ASOS MODIFICATION NOTE 14 (for Electronics Technicians)

SUBJECT	:	Software Version 2.0 for Voice Processor Board 1A2A20
PURPOSE	:	To add operational enhancements for the ASOS.
EQUIPMENT AFFECTED	:	ASOS
PARTS REQUIRED	:	Microcircuit P/N 62828-45010-1 Microcircuit P/N 62828-45011-1 Microcircuit P/N 62828-45012-1 Microcircuit P/N 62828-45013-1 Microcircuit P/N 62828-45014-1 Microcircuit P/N 62828-45015-1 Microcircuit P/N 62828-45016-1 Microcircuit P/N 62828-45017-1
MOD PROCUREMENT	:	The above parts will be provided through NLSC as ASOS Field Modification Kit (FMK) #60. ECPs E93SM05F075 and E93SM05F077
SPECIAL TOOLS REQUIRED	:	IC insertion tool Small flat-tipped screwdriver Conductive foam Electrostatic discharge (ESD) straps
TIME REQUIRED	:	1.5 hour
EFFECT ON OTHER INSTRUCTIONS	:	None.
CERTIFICATION STATEMENT	:	This modification was tested for operational integrity in the Engineering Design Branch laboratory and sites listed in Appendix B of ASOS Modification Note 10.

FIGURE 1

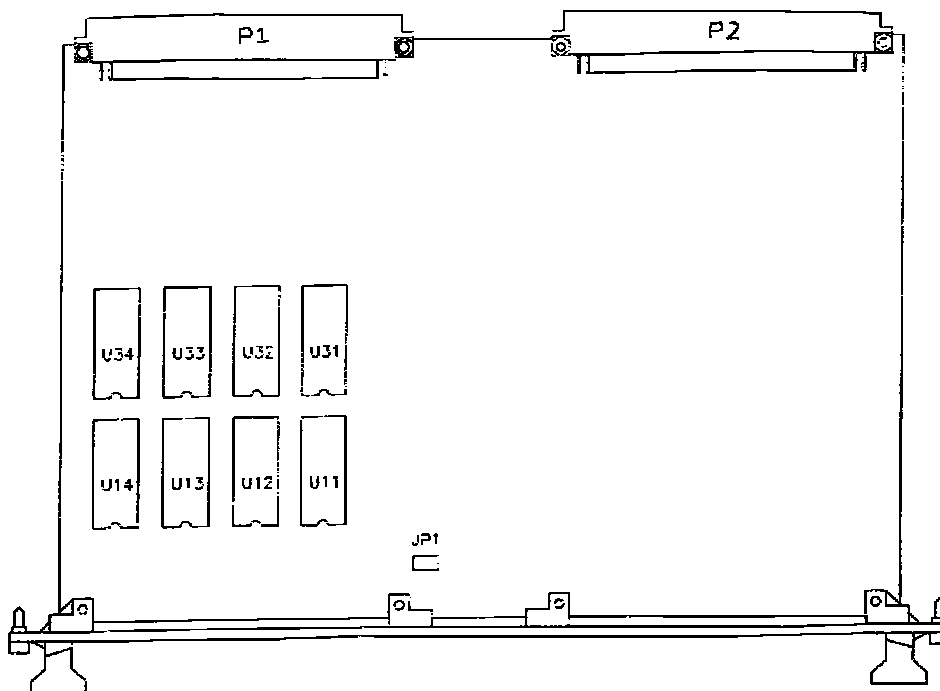
The procedure to upgrade the ACU voice firmware by removing and replacing the eight EPROMs on the Voice Processor board is followed. See Figure 1.

- 3. Using IC insertion tool, remove new EPROM integrated circuits from protective packaging and insert into Voice Processor board IC sockets in accordance with the following chart. Ensure that EPROMs are installed with pin 1 (as identified by notch in top of IC) oriented toward top of Voice Processor board as shown on Figure 1.

IC socket	IC Part number
U11	62828-45010-1
U12	62828-45011-1
U13	62828-45012-1
U14	62828-45013-1
U31	62828-45014-1
U32	62828-45015-1
U33	62828-45016-1
U34	62828-45017-1
